Large-scale Solar Association Comments

Submitted by	Company	Date Submitted
Rachel Gold, rachel@largescalesolar.org Danielle Osborn Mills, Danielle@largescalesolar.org	Large-scale Solar Association	2/19/2016

Clean Energy and Pollution Reduction Act Senate Bill 350 Study
Scope, Assumptions and Methodology

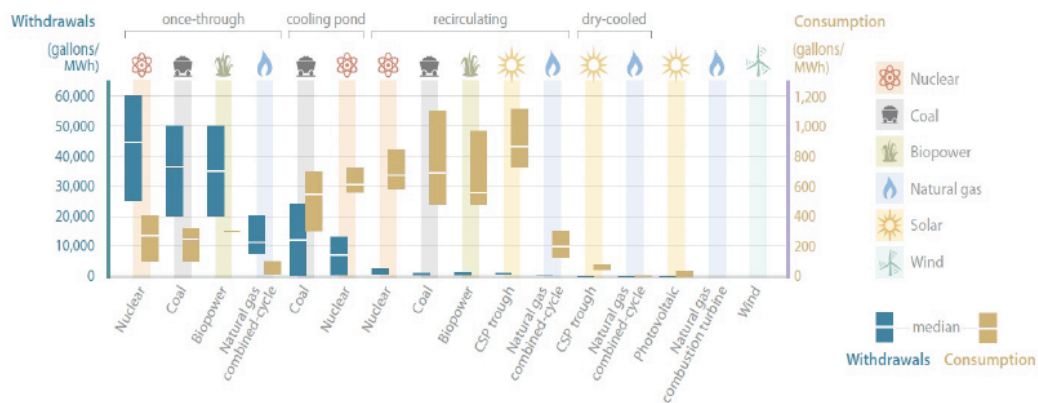
Finally, the Aspen presentation includes suggested metrics around water use and water supply as it relates to solar PV development. LSA wants to emphasize the water-reduction *benefits* of the conversion from fossil generation to solar PV, and encourages Aspen to incorporate these benefits into the model.

renewable portfolio standards, January 2016). The chart below gives a good general comparison of relative water use for various technologies. Aspen and the CAISO should consider taking a similar approach to its study to that used in this LBNL analysis. It is important to note, however, that this study relies on 2011 data and that the SB 350 environmental studies should seek more up-to-date figures in order to capture recent water efficiency innovations.
